**TOPOGRAPHIC SURVEY  
SEASPECT SHORT PLAT  
JOHN KAHAN**

PERMIT DRAWINGS  
 DATE: 06.10.22  
 SHEET SIZE: D (24X36)  
 REVISIONS

PROJECT TITLE:  
**Clarkson Residence**  
8163 West Mercer Way  
Mercer Island, WA 98040

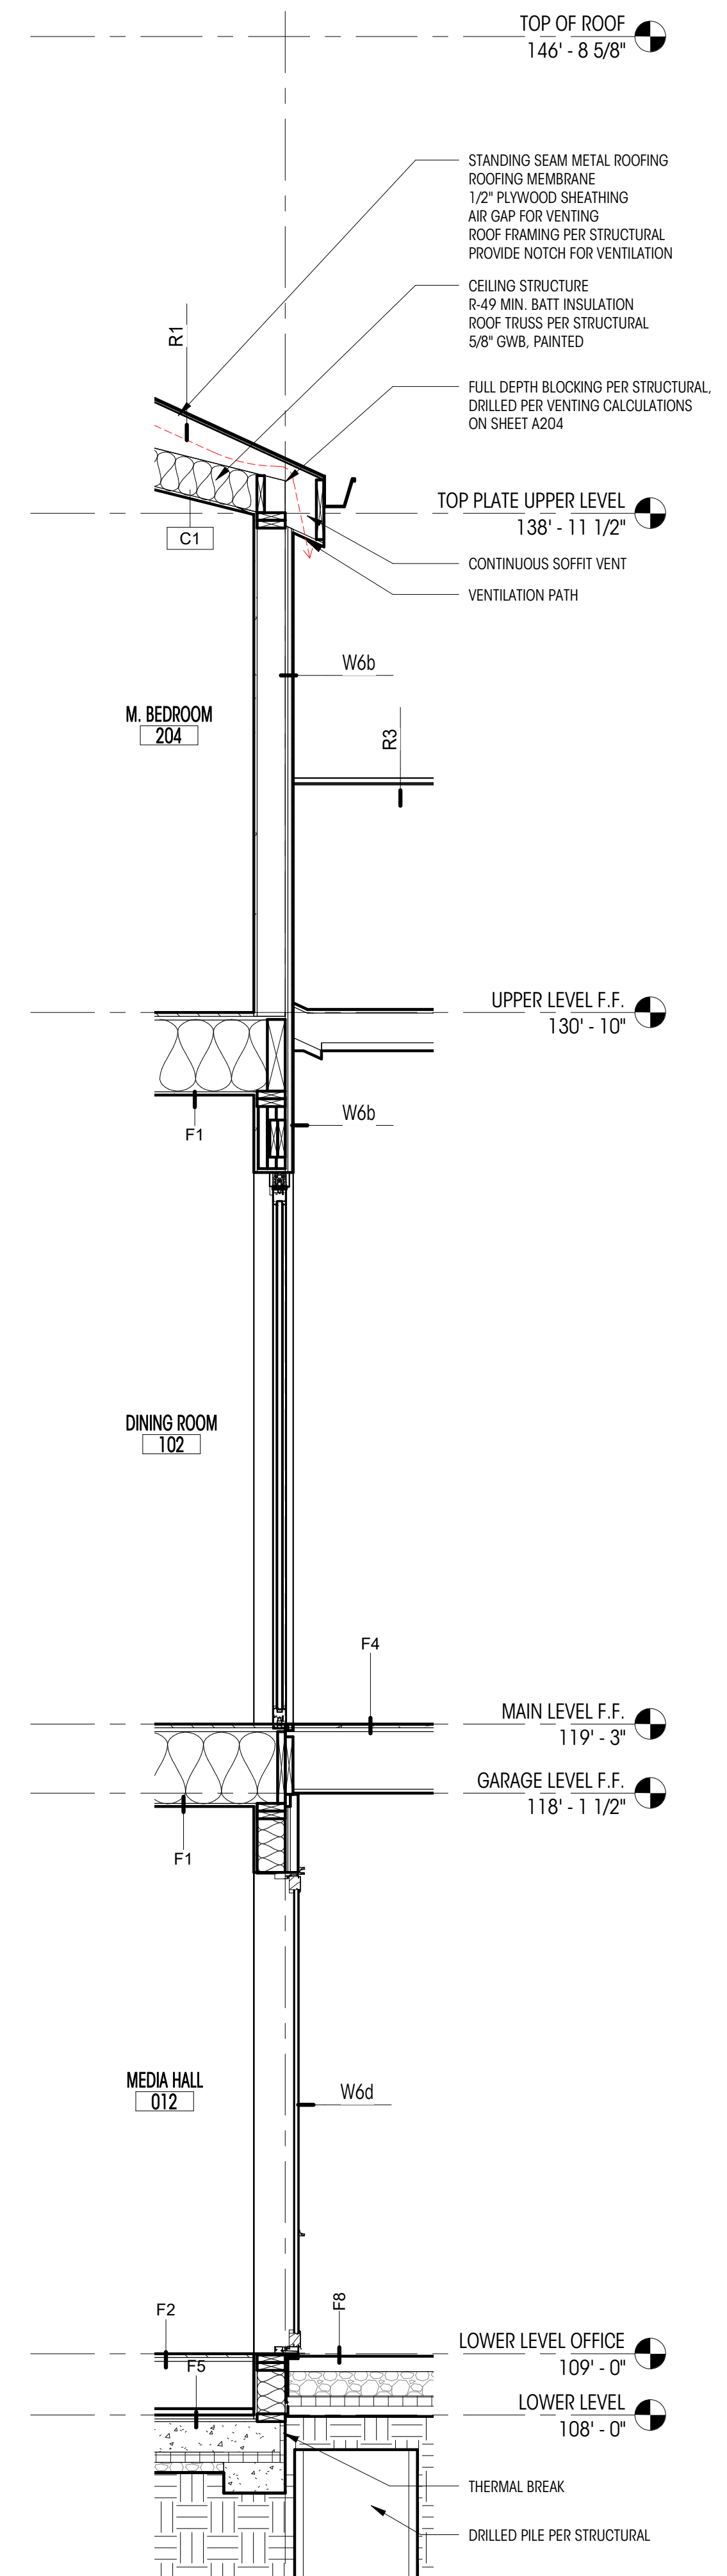
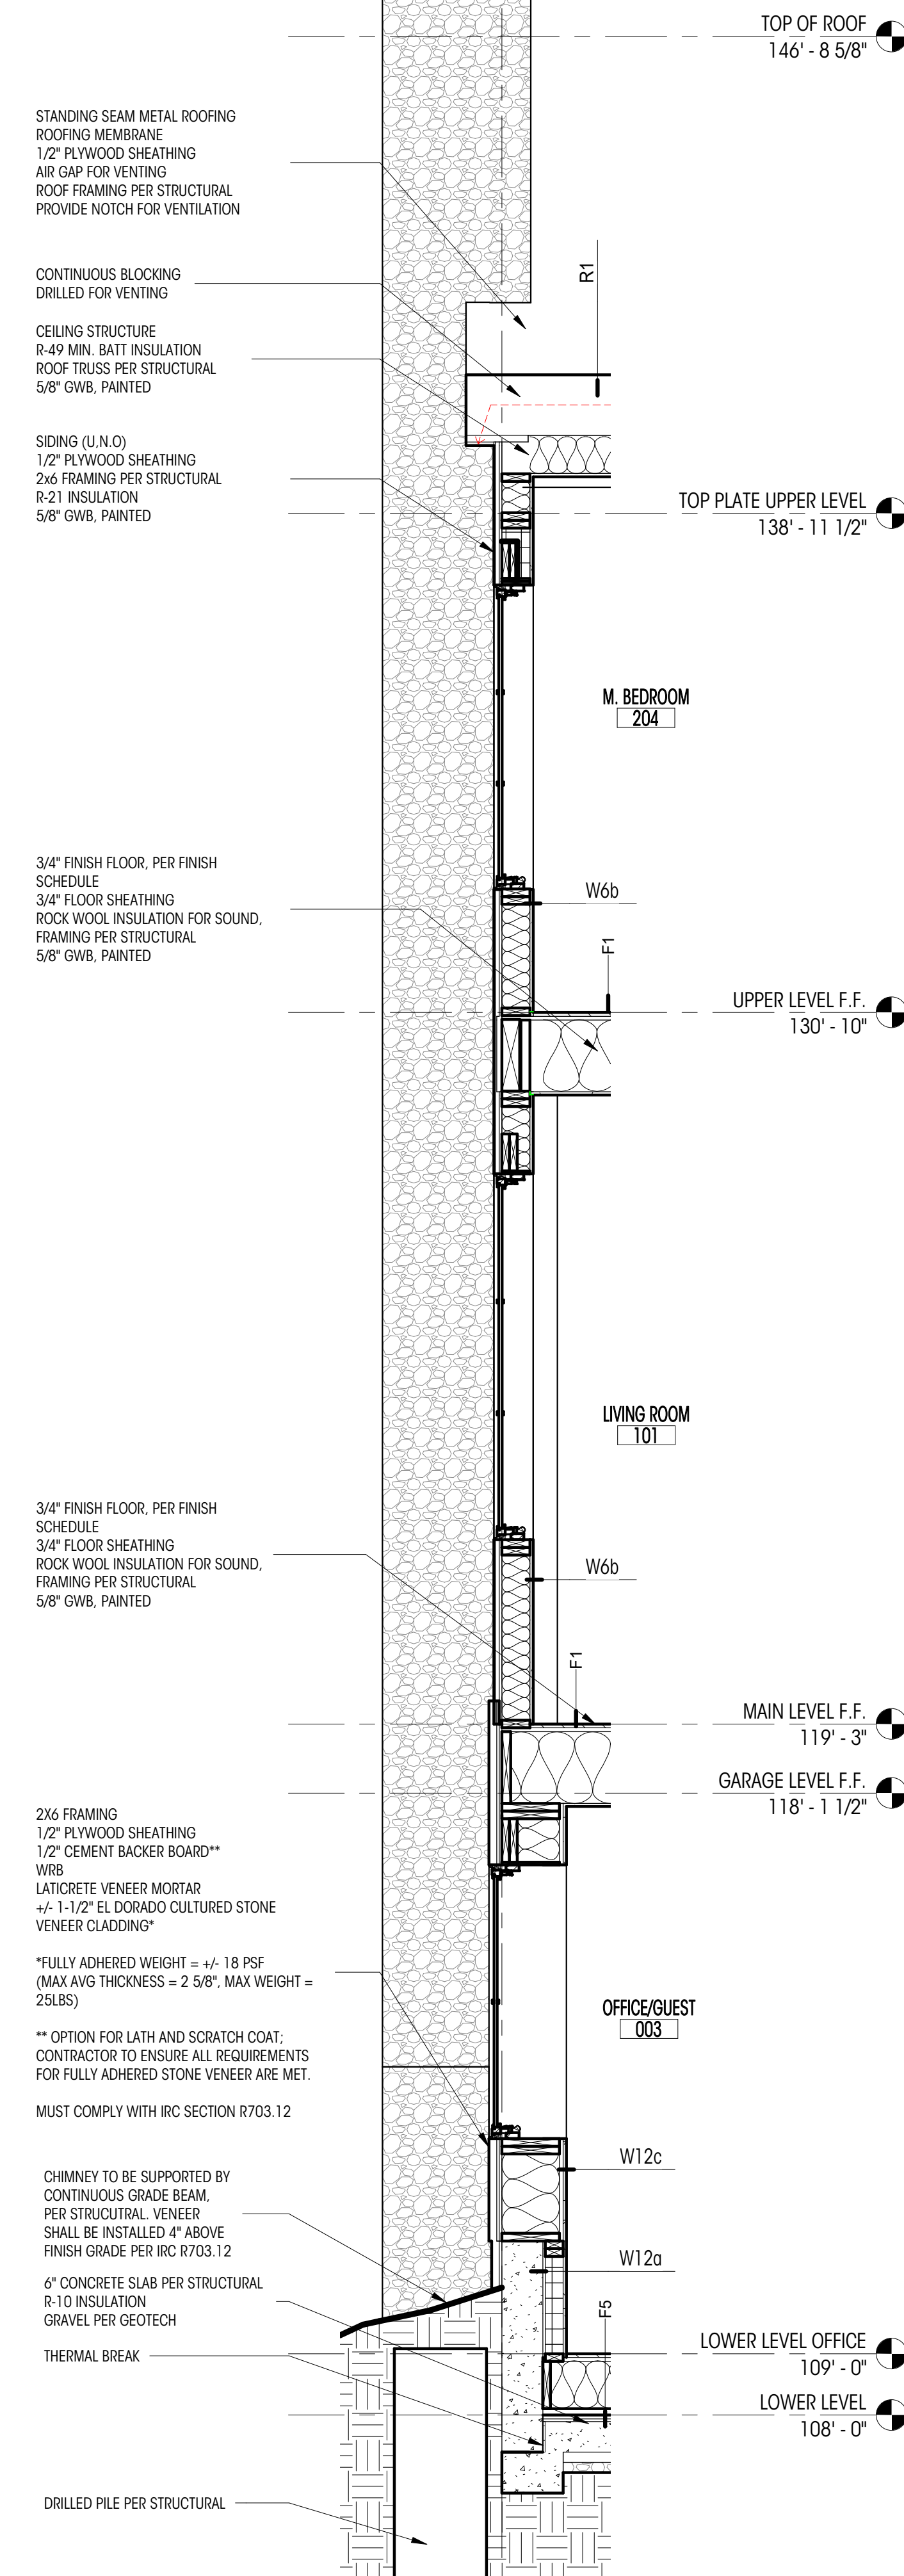
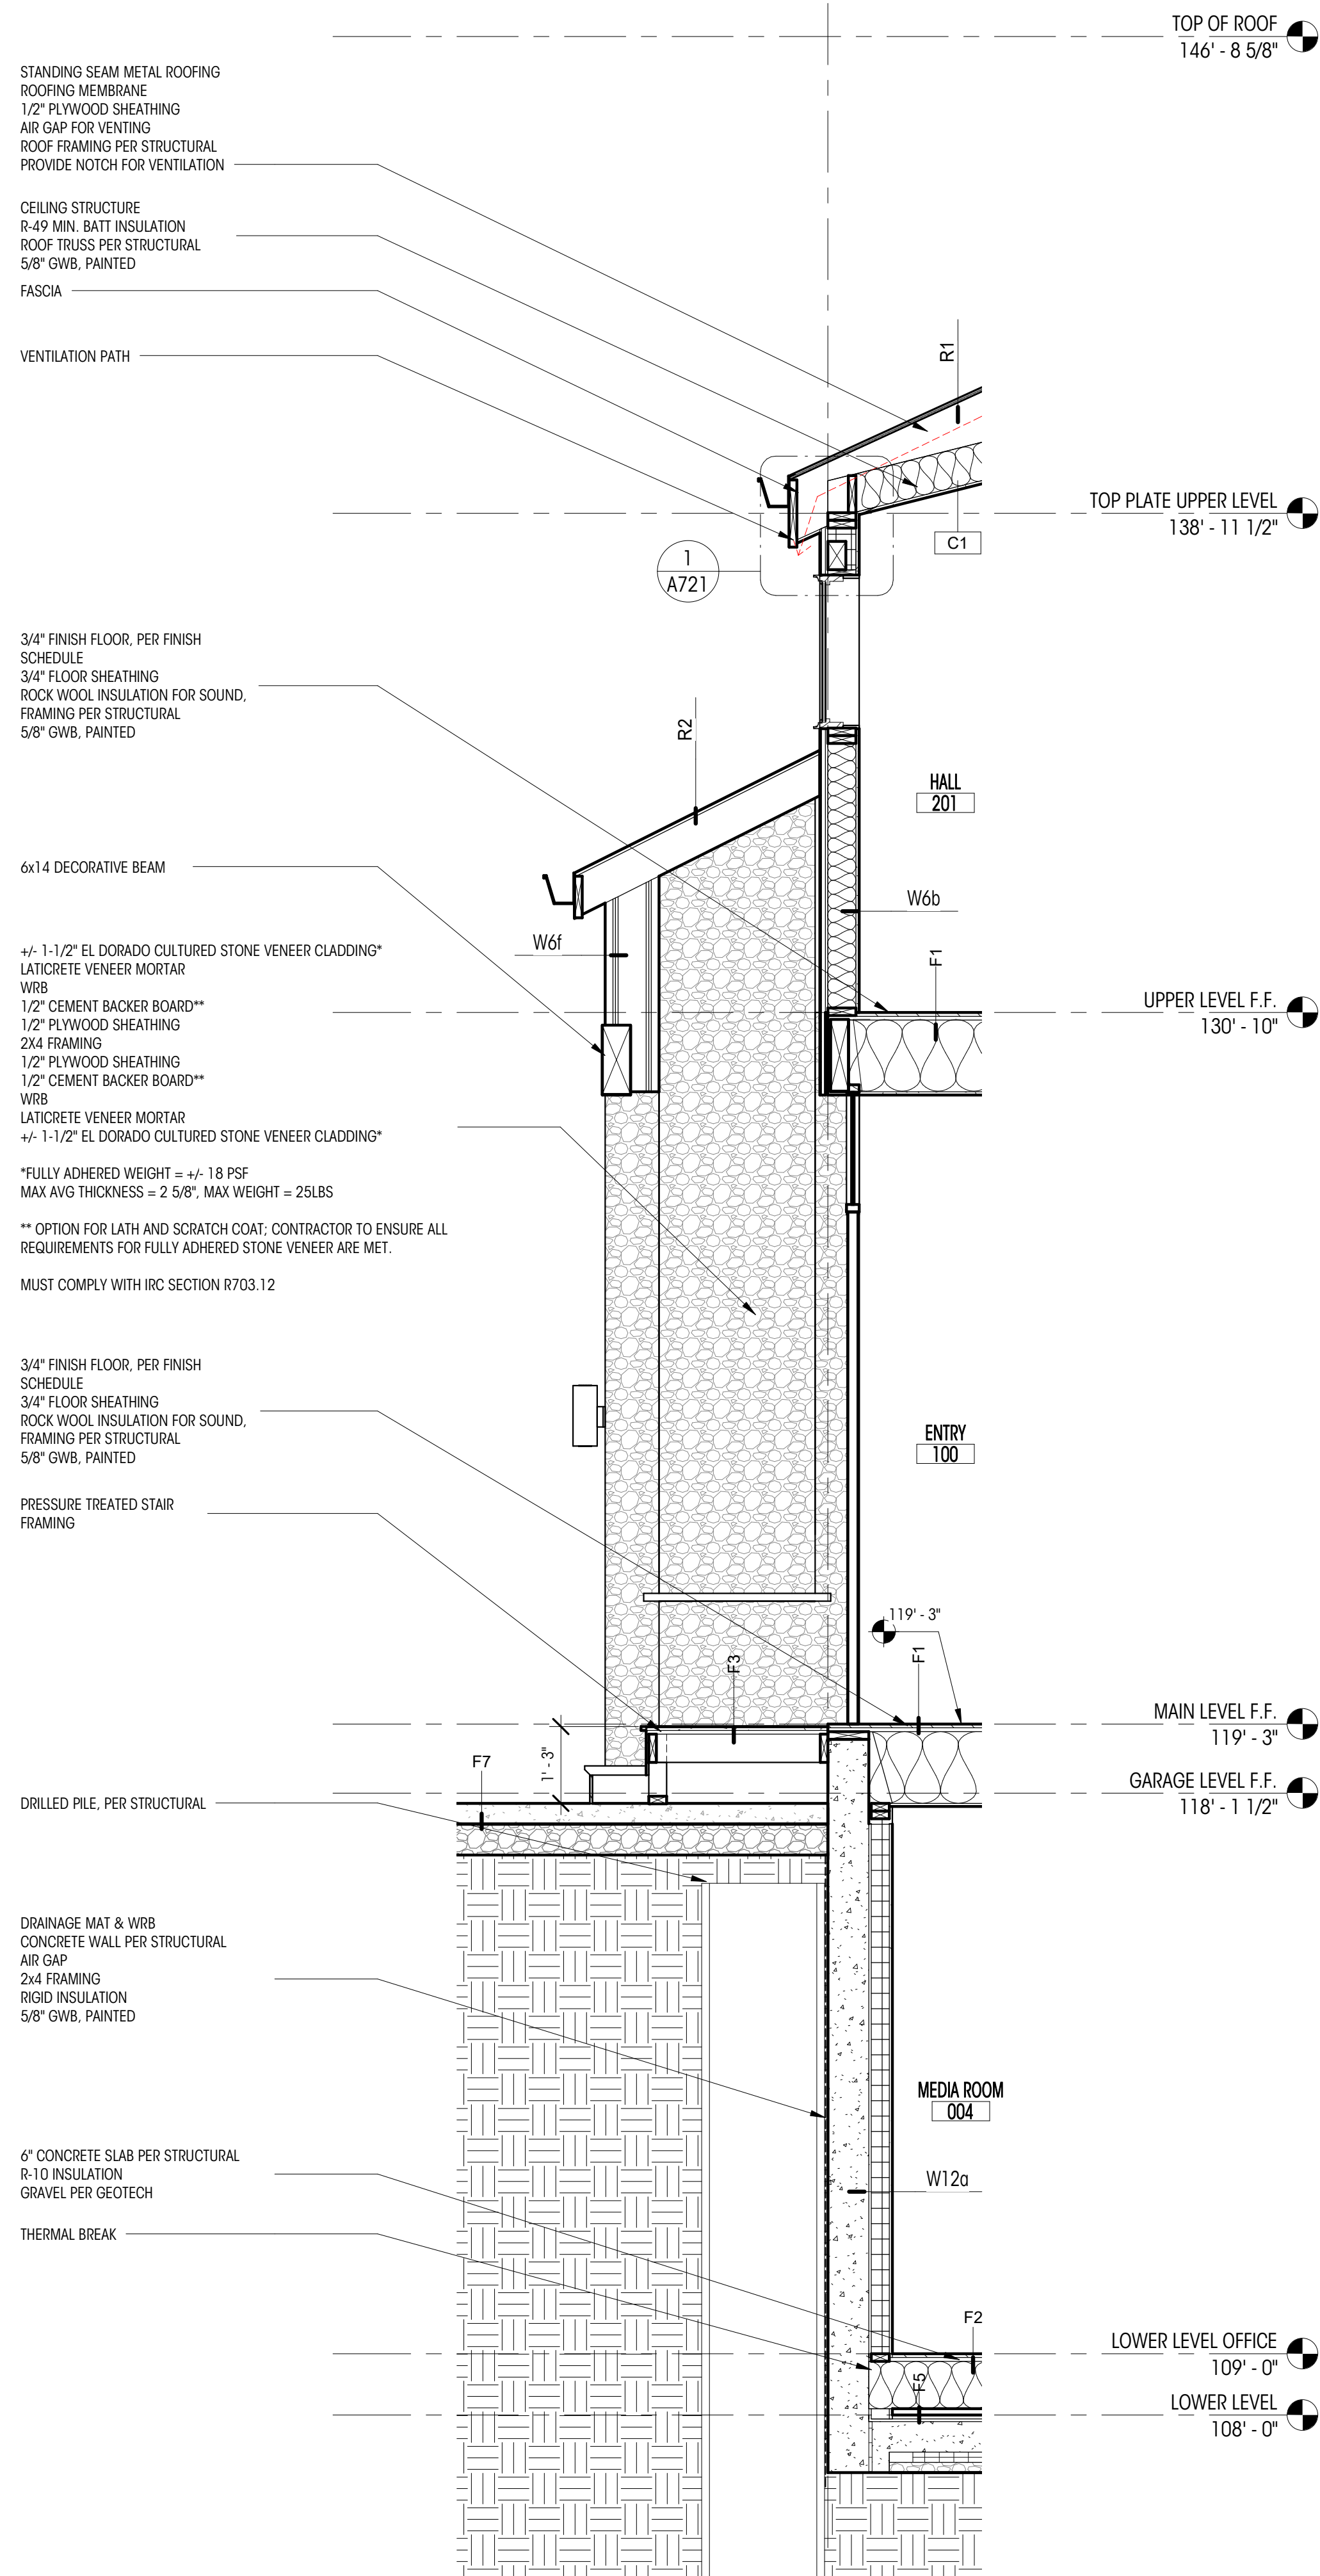
- VIEW NUMBERING UPDATED AND ADJUSTED FOR CLARIFICATION
- CHANGE ROOF OF AND EXTEND WESTERN PATIO TO THE WEST AND SOUTH
- LEVEL CHANGES: DRIVEWAY & GARAGE LEVEL DROP BY 12"; BASEMENT LEVEL DROP BY 12"

- ENTRY DESIGN CHANGE
- ADDED DORMERS AT UPPER LEVEL BONUS ROOM
- EXTEND GARAGE EAST INTO FRONT YARD SETBACK AS ALLOWED BY CODE 19.02.040.D
- SHEET LAYOUT ADJUSTED FOR ORGANIZATIONAL PURPOSES

- 1. "VIEW 1" WAS MOVED FROM SHEET A400 AND STAYED "VIEW 1"
- LEVEL CHANGES:
  - a. DRIVEWAY & GARAGE LEVEL DROP BY 15"
  - b. BASEMENT LEVEL DROP BY 12"
  - c. UPPER LEVEL DROP BY 2"

- d. FRAMED FLOOR 12" ABOVE BASEMENT FLOOR
  - e. CHANGE TO ABE AS A RESULT OF EXTENDED GARAGE AND EXTENDED COVERED DECK
  - f. CHANGE TO MAX HEIGHT AS A RESULT OF THE ADJUSTMENT TO THE ABE.
